A47 Wansford to Sutton Dualling

Volume 9 **9.11 Road Safety Audits**

Stage 1 Road Safety Audit

Road Safety Audit Response

Location: Sutton Heath Road. (Drawing; HE551494-GTY-HMK-000-DR-CH-30005).

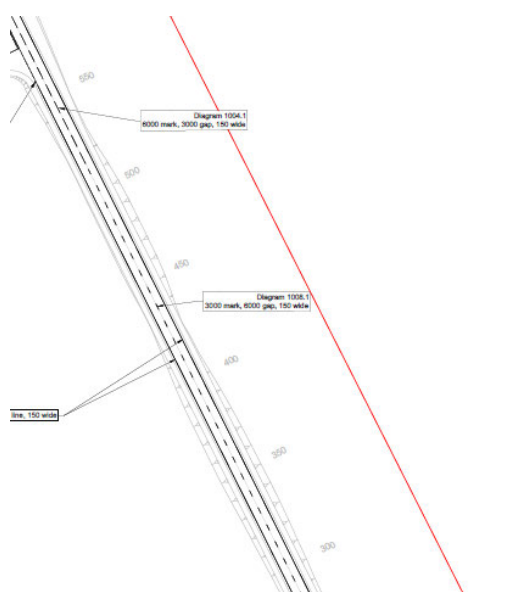
Summary: Straight, undulating alignment leads to high vehicle speeds and head-on collisions.

Description: The existing alignment of Sutton Heath Road will be straightened but will remain undulating. The straight alignment will likely encourage high vehicle speeds and the undulation could create limited forward visibility. These factors combined could lead to head-on collisions, particularly if overtaking occurs.

Recommendation: Design the road environment such that opposing vehicles and other hazards ahead can be clearly seen by vehicle drivers.

Problem 10	<p>Location: Sutton Heath Road. (Drawing: HE551494-GTY-HMK-000-DR-CH-30005).</p> <p>Summary: Straight, undulating alignment leads to high vehicle speeds and head-on collisions.</p> <p>Description: The existing alignment of Sutton Heath Road will be straightened but will remain undulating. The straight alignment will likely encourage high vehicle speeds and the undulation could create limited forward visibility. These factors combined could lead to head-on collisions, particularly if overtaking occurs.</p> <p>Recommendation: Design the road environment such that opposing vehicles and other hazards ahead can be clearly seen by vehicle drivers.</p>	<p>Design the road environment such that opposing vehicles and other hazards ahead can be clearly seen by vehicle drivers.</p>	<p>Agree with Problem and Recommendation:</p> <p>We are providing full SSD, though not FOSD (full overtaking sight distance), so the road is intended to be appropriately marked to indicate that overtaking is not permitted.</p> <p>Sutton Heath Road will be closed to vehicles and only used as NMU route. Only the landowners will have vehicular access to that section of the road.</p>	Agree with Supplier	Old Sutton Heath Road to be closed to vehicles and only used for WCHR route and landowner access.

Location: Proposed access to Great North Road houses (Drawing: HE551494-GTY-HFE-000-DR-CH-30001).

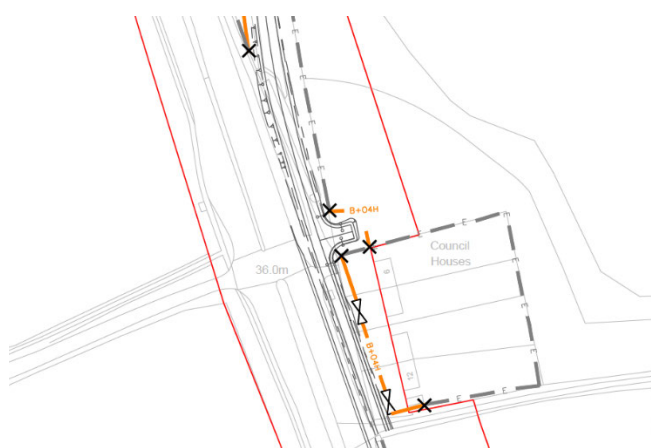
Summary: Headlight glare dazzles drivers, leading to loss of control.

Description: A new access road for a row of houses adjacent to the A1 is proposed, to remove the need for the current direct access. The new access road will run parallel, and very close, to the A1 southbound carriageway. It does not appear that any fencing is proposed between the A1 and the new access road. Headlight glare from cars travelling on the access road could dazzle and confuse drivers on the A1, leading to loss of control collisions.

Recommendation: Provide a form of physical barrier between the A1 carriageway and the new access for the Great North Road houses, such that headlight see-through is prevented.

4.2. Fences and Road Restraint Systems					
Problem 11	<p>Location: Proposed access to Great North Road houses (Drawing: HE551494-GTY-HFE-000-DR-CH-30001).</p> <p>Summary: Headlight glare dazzles drivers, leading to loss of control.</p>	<p>Provide a form of physical barrier between the A1 carriageway and the new access for the Great North Road houses, such that</p>	<p>Agree with Problem and Recommendation:</p> <p>A safety barrier and an anti-glare fence is proposed between A1 and the new access in the last design iteration.</p>	Agree with Supplier	Safety barrier and anti-glare fence to installed as per latest design iteration

Location: Peterborough Road, near the proposed new roundabout.
(Drawing: HE551494-GTY-HFE-000-DR-CH-30006).

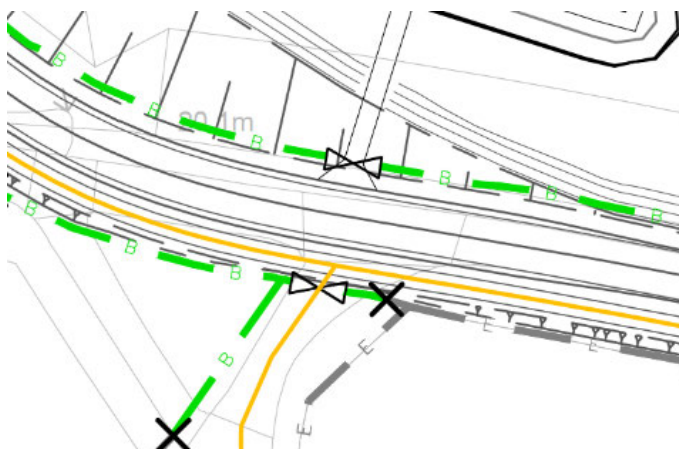
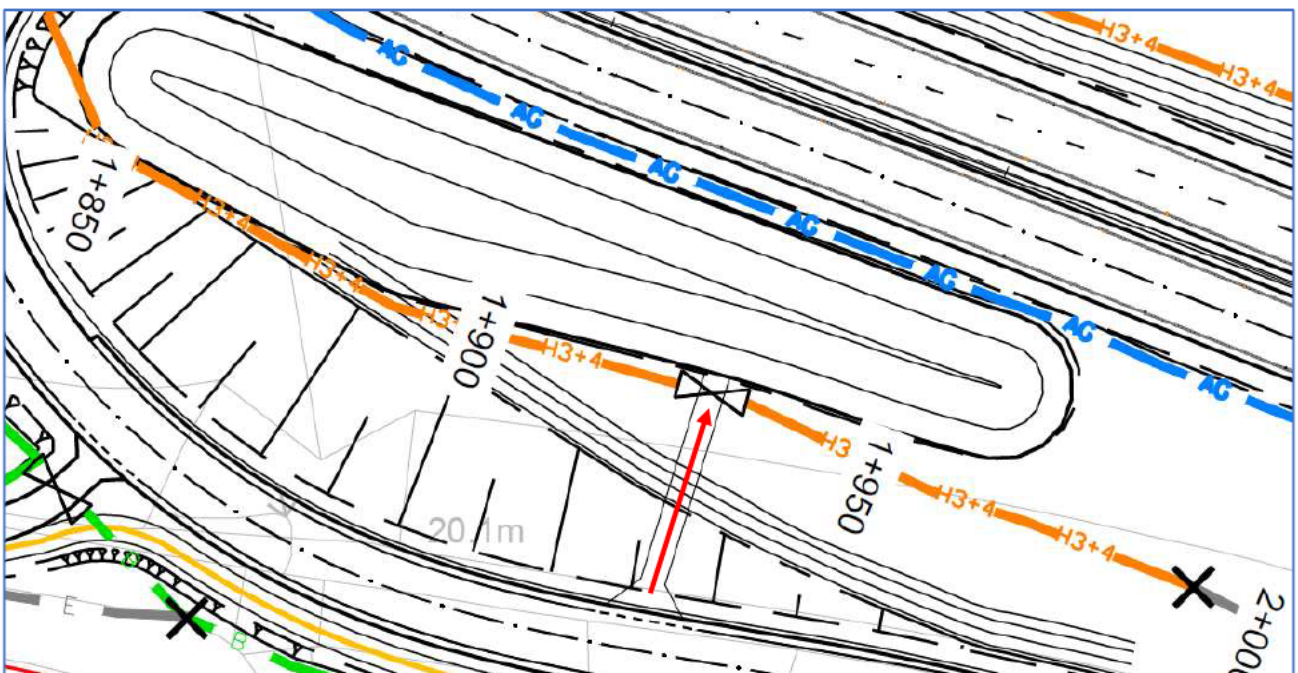
Summary: Maintenance vehicles unable to pull off carriageway fully.

Description: A gated, vehicular access is proposed off Peterborough Road for a new attenuation basin. The gate does not appear to be positioned far enough from the carriageway to allow a maintenance vehicle to pull off the carriageway fully whilst the gate is being opened. This may lead to vehicles striking maintenance vehicles waiting to access the basin.

Recommendation: Ensure the gate is positioned such that the largest maintenance vehicles envisaged can pull fully off the carriageway while the gate is being opened.

Reference	RSA problem	RSA recommendation	Design organisation response	Overseeing Organisation response	Agreed RSA action
	Description: A new access road for a row of houses adjacent to the A1 is proposed, to remove the need for the current direct access. The new access road will run parallel, and very close, to the A1 southbound carriageway. It does not appear that any fencing is proposed between the A1 and the new access road. Headlight glare from cars travelling on the access road could dazzle and confuse drivers on the A1, leading to loss of control collisions.	headlight see-through is prevented.			
Problem 12	Location: Peterborough Road, near the proposed new roundabout. (Drawing: HE551494-GTY-HFE-000-DR-CH-30006). Summary: Maintenance vehicles unable to pull off carriageway fully. Description: A gated, vehicular access is proposed off Peterborough Road for a new attenuation basin. The gate does not appear to be positioned far enough from the carriageway to allow a maintenance vehicle to pull off the carriageway fully whilst the gate is being opened. This may lead to vehicles striking maintenance vehicles waiting to access the basin.	Ensure the gate is positioned such that the largest maintenance vehicles envisaged can pull fully off the carriageway while the gate is being opened.	Agree with Problem and Recommendation: Fence and gate at pond access are set further back to allow maintenance vehicle to exit Peterborough road in the last design iteration. See Appendix - A Problem 12	Agree with Supplier	Fence and gate at pond access are now set further back to allow maintenance vehicle to exit Peterborough road in the last design iteration.

Location: A1 / A47 junction, eastern roundabout.

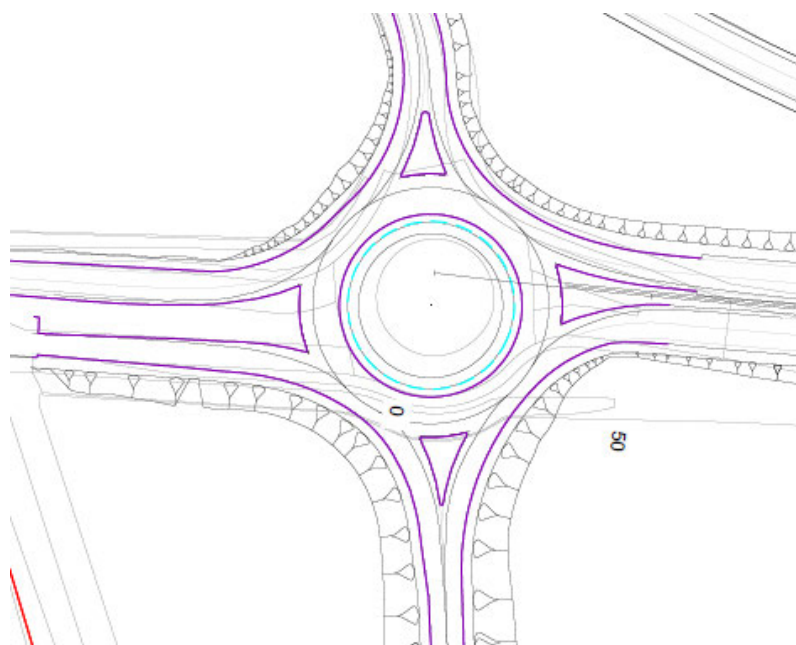
Summary: Lack of cycle facilities leads to vehicle / cyclist conflicts.

Recommendation: Provide suitable cycle infrastructure at the newly enlarged roundabout.

Location: Junction of new link road and new link to Sacrewell Farm.
(Drawing: HE551494-GTY-HGN-000-DR-CH-30017).

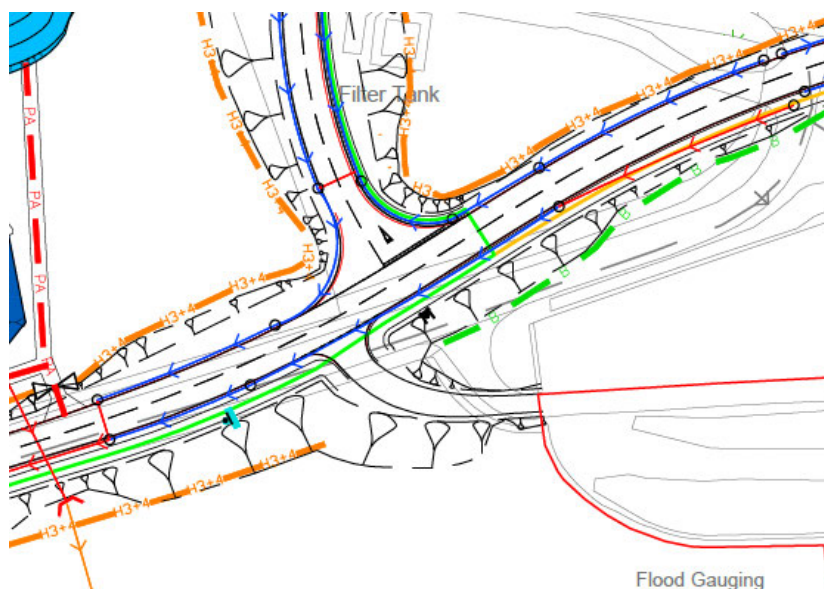
Summary: Lack of sufficient crossing facilities leads to vehicle / NMU collisions.

Description: The proposed NMU facilities at the junction of the new link road and the new link to Sacrewell Farm will create a need for pedestrians, cyclists and horse-riders to cross the new link road if routing to or from Sacrewell Farm. If the area becomes well used by vehicles and NMUs then this may create the potential for conflicts and collisions if suitable crossing facilities are not provided. An uncontrolled crossing point only is proposed.

Recommendation: Ensure the design allows NMUs to safely cross the new link road to access the new link to Sacrewell Farm.

Problem 15	Location: Junction of new link road and new link to Sacrewell Farm. (Drawing: HE551494-GTY-HGN-000-DR-CH-30017). Summary: Lack of sufficient crossing facilities leads to vehicle / NMU collisions. Description: The proposed NMU facilities at the junction of the new link road and the new link to Sacrewell Farm will create a need for pedestrians, cyclists and horse-riders to cross the new link road if routing to or from Sacrewell Farm. If the area becomes well used by vehicles and NMUs then this may create the potential	Ensure the design allows NMUs to safely cross the new link road to access the new link to Sacrewell Farm.	Agree with the problem and recommendation. The Walking, Cycling and Horse Riding assessment and review identified the requirement for a crossing point at this junction which has been provided within the preliminary design on the east side of the junction, connecting the path on Sacrewell farm road to the link road. The new link road is primarily designed for the filling station access and is therefore not expected to have a significant traffic volume.	Agree with Supplier WCHR route situated to east of Sacrewell access and therefore crossing point would avoid most of the traffic with clear visibility for service stations movements	WCHR route situated to east of Sacrewell access and therefore crossing point would avoid most of the traffic with clear visibility for service stations movements Signage details to be provided as part of detailed design.

Reference	RSA problem	RSA recommendation	Design organisation response	Overseeing Organisation response	Agreed RSA action
	for conflicts and collisions if suitable crossing facilities are not provided. An uncontrolled crossing point only is proposed.		The crossing point has been located at a point where it achieves the visibility for the Design Speed and Speed Limit of the link road. In addition to the above, warning signs for pedestrians crossing are provided on both approaches to the crossing. Final solution will be further developed at the detailed design stage.	Signage details to be provided as part of detailed design.	Link to the Petrol station after the Sacrewell junction only used for Petrol station users. Very low traffic expected in this area. Further analysis will be done in detailed design, Stage 5.
Problem 16	Location: Shared foot / cycleway near Sutton Heath Road. (Drawing: HE551494-GTY-HGN-000-DR-CH-30023). Summary: Steep gradient and sharp bends lead to cyclists' loss of control or collisions with pedestrians. Description: A shared cycle / footway is proposed underneath the new A47 alignment, near Sutton Heath Road. There is a significant level difference between the underpass and both Sutton Heath Road and the existing A47, to which the cycle / footway will connect. Sloping paths are proposed on either side of the underpass, with sharp right-angles. Cyclists using these paths could lose control on the bends or collide with pedestrians.	Design the sloping sections of the shared foot/cycleway such that cyclists and pedestrians can safely use the facility.	Agree with Problem and Recommendation: The design follows NMU guidance, landings are provided in design to control speeds. Gradient required in land available informs the right-angle design; landings are considered appropriate for controlling speeds. 3m width anticipated to be sufficient for minimising conflicts for NMUs using the facility. Should this solution require further work, it will be addressed at SGAR 5.	Agree with Supplier	The design follows NMU guidance, landings are provided in design to control speeds. Gradient required in land available informs the right-angle design; landings are considered appropriate for controlling speeds. 3m width anticipated to be sufficient for minimising conflicts for NMUs using the facility. Should this solution require further work, it is to be addressed at SGAR 5.

Location: Shared foot / cycleway near Sutton Heath Road. (Drawing: HE551494-GTY-HGN-000-DR-CH-30023).

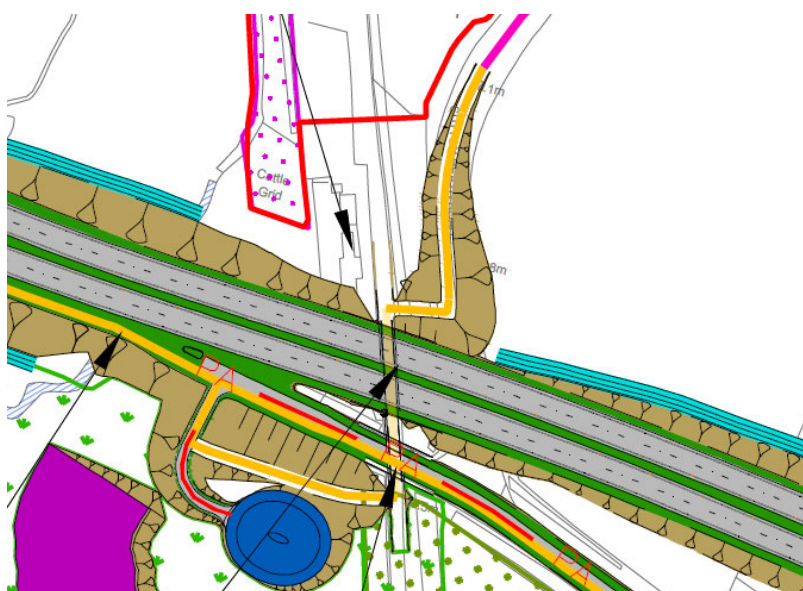
Summary: Steep gradient and sharp bends lead to cyclists' loss of control or collisions with pedestrians.

Description: A shared cycle / footway is proposed underneath the new A47 alignment, near Sutton Heath Road. There is a significant level difference between the underpass and both Sutton Heath Road and the existing A47, to which the cycle / footway will connect. Sloping paths are proposed on either side of the underpass, with sharp right-angles. Cyclists using these paths could lose control on the bends or collide with pedestrians.

Recommendation: Design the sloping sections of the shared foot/cycleway such that cyclists and pedestrians can safely use the facility.

Location: Peterborough Road, at eastern tie-in (Drawing: HE551494-GTY-HGN-000-DR-CH-30023).

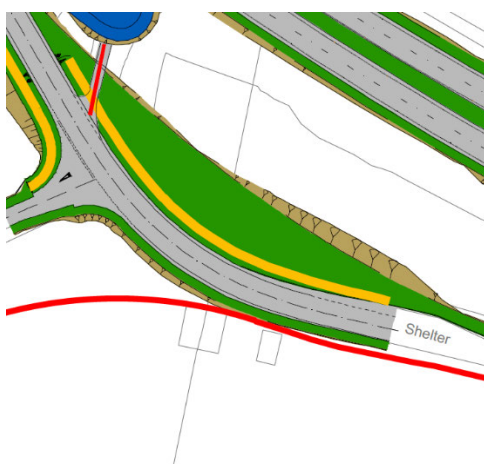
Summary: Cyclists re-joining carriageway struck by vehicles.

Description: The proposed shared foot / cycleway on the northern side of Peterborough road ends at an existing layby. It is unclear how cyclists will safely re-join the carriageway on what is a national speed limit road with potentially high vehicle speeds. Cyclists re-joining the carriageway unexpectedly could be struck by vehicles.

Recommendation: Provide a safe means for cyclists to re-join the carriageway.

Problem 18	Location: Peterborough Road, at eastern tie-in (Drawing: HE551494-GTY-HGN-000-DR-CH-30023). Summary: Cyclists re-joining carriageway struck by vehicles. Description: The proposed shared foot / cycleway on the northern side of Peterborough road ends at an existing layby. It is unclear how cyclists will safely re-join the carriageway on what is a national speed limit road with potentially high vehicle speeds. Cyclists re-joining the carriageway unexpectedly could be struck by vehicles.	Provide a safe means for cyclists to re-join the carriageway.	Agree with Problem and Recommendation: The design will be updated for SGAR 5 to provide an extension of the proposed foot/ cycleway to the east past the bus layby for cyclists to enter the carriageway. Traffic signs to Diagram 966 will be provided to advise cyclists to join the carriageway. Warning sign to Diagram 950 will be provided on Peterborough Road eastbound on approach to the location where cyclists are joining the road.	Agree with Supplier	The design is to be updated for SGAR 5 to provide an extension of the proposed foot/ cycleway to the east past the bus layby for cyclists to enter the carriageway. Traffic signs to Diagram 966 will be provided to advise cyclists to join the carriageway. Warning sign to Diagram 950 will be provided on Peterborough Road eastbound on approach to the location where cyclists are joining the road.

Location: A1 southbound (Drawing: HE551494-GTY-HSN-000-DR-CH-30001 and HE551494-GTY-HSN-000-DR-CH-30002).

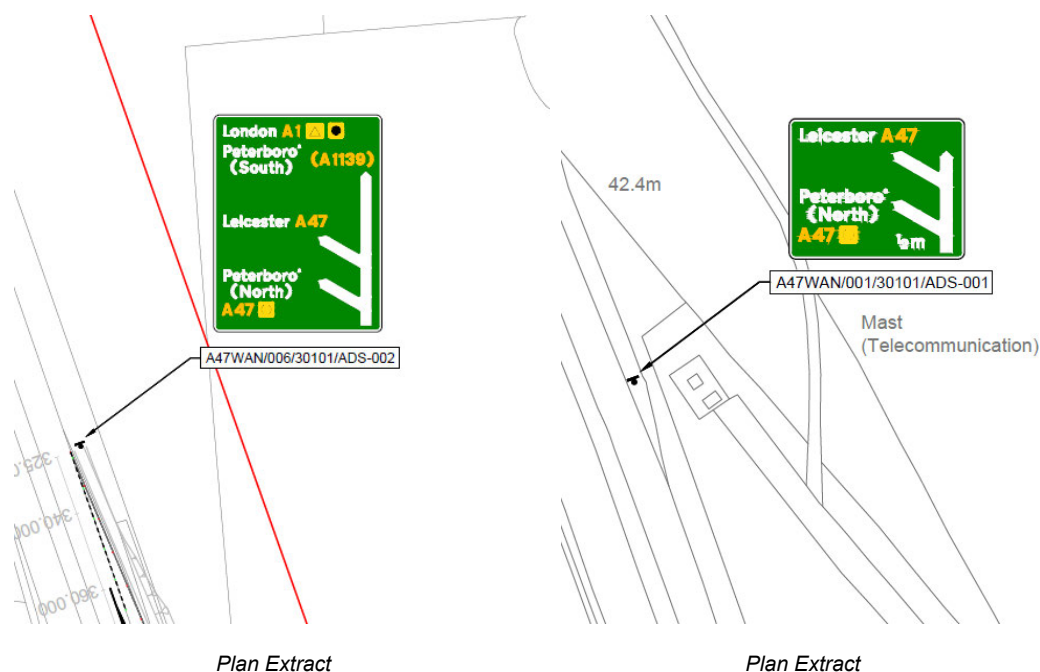
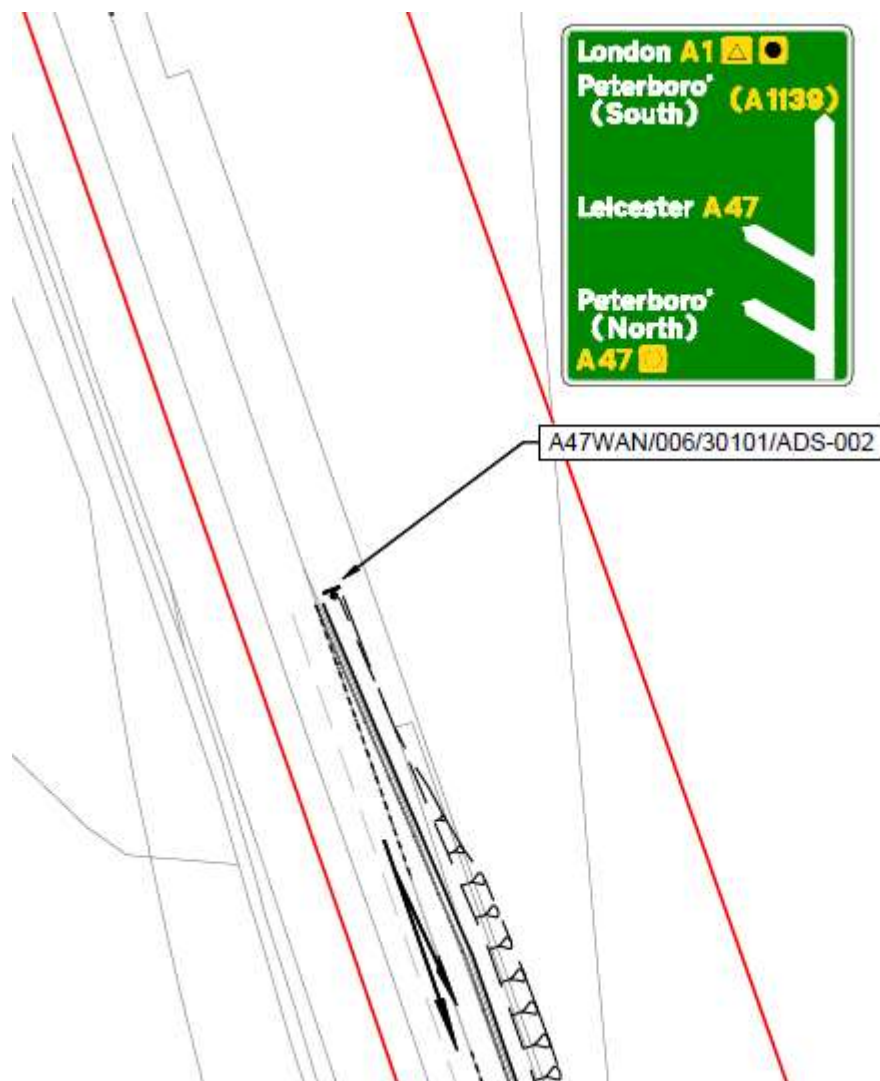
Summary: Traffic signs do not reflect the road layout.

Description: Proposed traffic signs A47WAN/006/30101/ADS-001, 002, and 003 include angled arrows for both exits. This design suggests that both the new freeflow link and the existing exit for Wansford junction have relatively straight slip roads. However, this is not the case with the existing (A47 Leicester) exit, which has quite a severe double turn which drivers may not be expecting based on the sign design.

Recommendation: Provide sign designs that reflect the characteristics of the road layout.

Problem 19	Location: A1 southbound (Drawing: HE551494-GTY-HSN-000-DR-CH-30001 and HE551494-GTY-HSN-000-DR-CH-30002). Summary: Traffic signs do not reflect the road layout. Description: Proposed traffic signs A47WAN/006/30101/ADS-001, 002, and 003 include angled arrows for both exits. This design suggests that both the new freeflow link and the existing exit for Wansford junction have relatively straight slip roads. However, this is not the case with the existing (A47 Leicester) exit, which has quite a severe double turn which drivers may not be expecting based on the sign design.	Provide sign designs that reflect the characteristics of the road layout.	Disagree with problem.: The proposed advance direction signage is designed in accordance with Traffic Signs Manual Chapter 7 for grade separated exit slip roads. These signs do not provide a representation of the road alignment but reflect the fact that the junctions are grade separated. To highlight the alignment of the existing A47 (Leicester) exit slip road, 'SLOW' road markings and warning signs will be provided on the approach to the exit. This will be detailed in the SGAR 5 design. Appendix A shows the current and the proposed warning signs.	Agree with Audit that signs could be misleading for A47 Leicester exit. The A47 Leicester slip is for a grade separated junction however the A47 Peterborough dedicated slip is for an at grade exit. Further details to be incorporated as part of detailed design. Supplier to provide risk assessment to support position.	Design to ensure consistent signage as part of detailed design. All signage to show two diverge layout. Technical note (Appendix B) to be provided to provide more detail on decision.
